TOWN OF CARMEL
PLANNING BOARD

PLANNING BOARD AGENDA
MAY 9, 2024 – 7:00 P.M.

RE: DAG Route 6 LLC
395 US Route 6
Town of Carmel
TM# 75.19-1-8 & 75.20-2-5

In response to open comments received from Code Enforcement Director, Michael Carnazza, dated March 27, 2024, we offer the following responses:

PROPOSED (SOUTH) ELEVATION

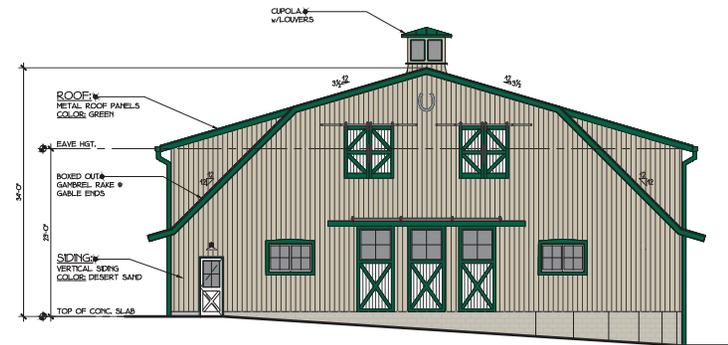
In response to an outstanding comment from Town Planner, Patrick Cleary, the applicant has added a horizontal banding above the doors of the building, per the enclosed renderings.

DRAWING:
SITE PLAN

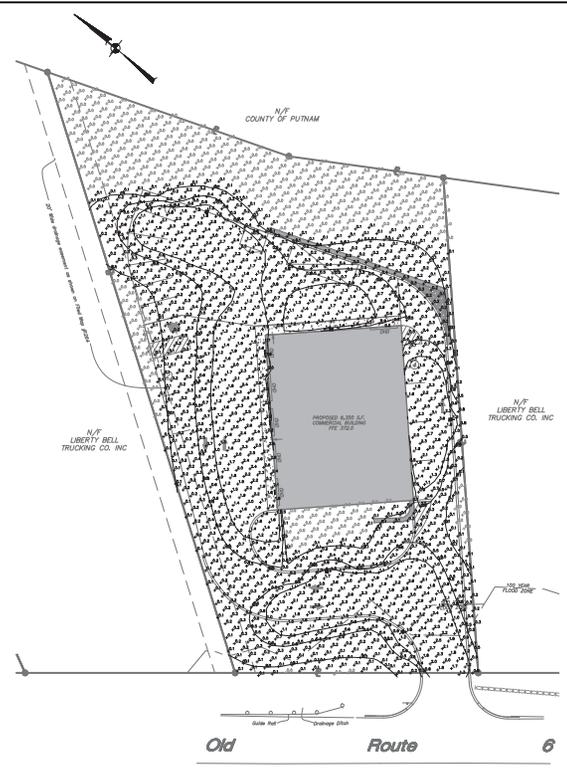
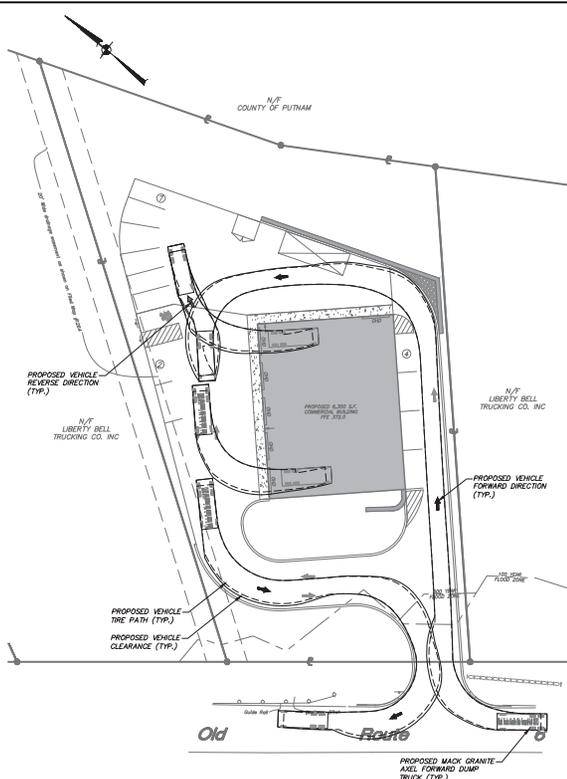
1. This comment is acknowledged.
2. Traffic and vehicle movement plans are provided on drawing SP-4. The driveway has been graded to meet the suggested slopes. Turning radii and sight distances are shown on drawing SP-1.

6. A photometric lighting plan is provided on drawing SP-4.
7. Signage and pavement markings are provided.
8. It is noted this project will disturb less than one acre. Stormwater will be collected in the proposed drainage structures and will be conveyed to the existing 30" HDPE pipe, which outlets to the existing drainage ditch along Old Route 6. It is noted there is an overall decrease in impervious surfaces as much of the currently gravel surfaces will be removed to create landscape areas. Our office will coordinate with the Town Engineer regarding any treatment requirements.

DRY POND PLAN VIEW
SCALE: 1"=20"

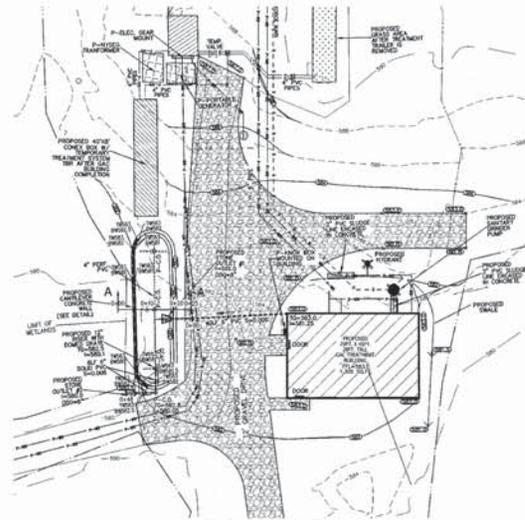
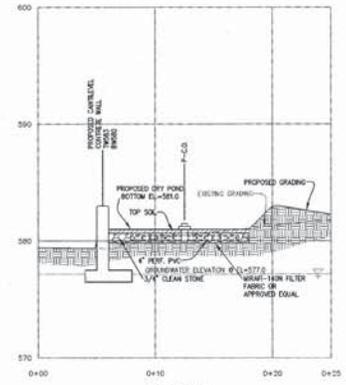
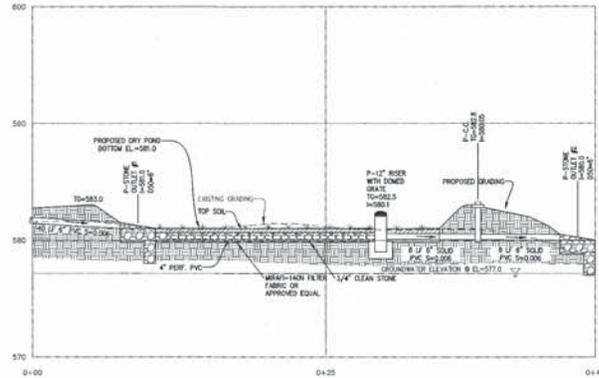
2. Comment: The wetland encroachment by new building location, stormwater management facilities and gravel driveway have been approved by the NYSDEC and US Army Corps of Engineers. ECB approval is now also required.

Response: To eliminate any disturbance of the wetlands we have revised the Site Plan to incorporate a retaining wall on the west end of the proposed dry pond. The new design obviates the need to grade within or otherwise permanently disturb the wetlands. Therefore, wetland mitigation measures will no longer be necessary.

The dry pond (previously labeled as a “rain garden” on the previous set of plans) has been redesigned to avoid impacts to the wetland. As seen on the plan view (Sheet 4) and the details (Sheet 5), the earth embankment on the west side of the dry pond has been replaced using a concrete wall. This will allow for the needed footprint of the pond but without encroaching on the wetland.
